NASA/TM-2009-215910
NESC-RP-08-70/08-00456

Ares I-X Vibroacoustic Environments

Ares I-X Vibroacoustic Environments

4.0 Executive Summary

Figure 6.0-1. Vibroacoustic Qualification Flowchart

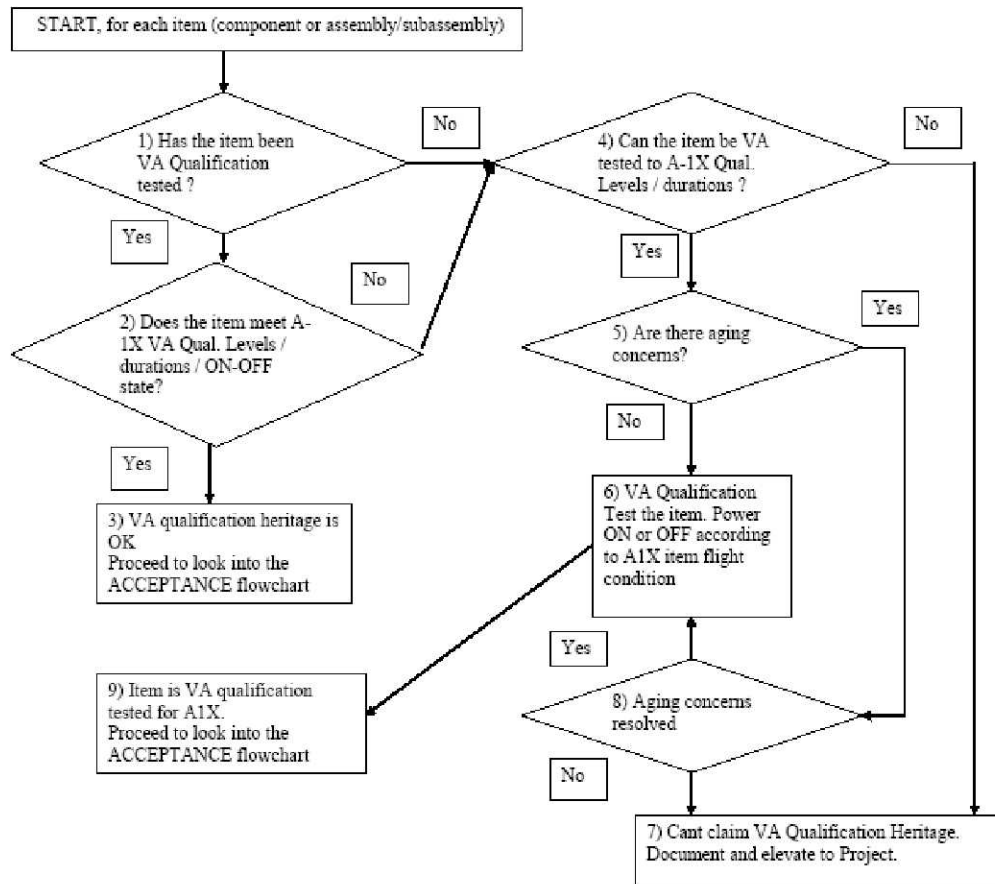
A recommended decision process flow for considering RoCS VA Qualification is provided in Figure 6.0-1, and a similar decision process for Acceptance is provided in Figure 6.0-2. Tables 6.0-1 and 6.0-2, respectively, provide more detailed commentary for each flowchart block item.

Block #	Qualification Flowchart Description
1	The data should include the item qualification random vibration test report and/or acoustic test report. Input for test specifications, tolerances, actual input test data, pre- and post-functional and structural integrity checks data is desired.
2	To compare heritage and A-1X qualification specification test magnitudes, durations, axes of exposure and power status during vibration (ON or OFF).
3	The item is declared "VA heritage qualified". Now proceed to the acceptance flowchart.
4	Feasibility to include item configuration, facility capabilities.
5	Related to failure modes that could originate due to aging. For example material creep, seals / joints aging or degradation and stiffness changes.
6	Qualification to the A-1X VA environment (non flight item).
7	Qualification heritage cannot be claimed from the VA perspective. The item VA evaluation has to be elevated to the Project for acceptance under a different justification (waiver) or rejection.

8	For example replacing a seal or a G10 washer.
9	Similar to Block #3.
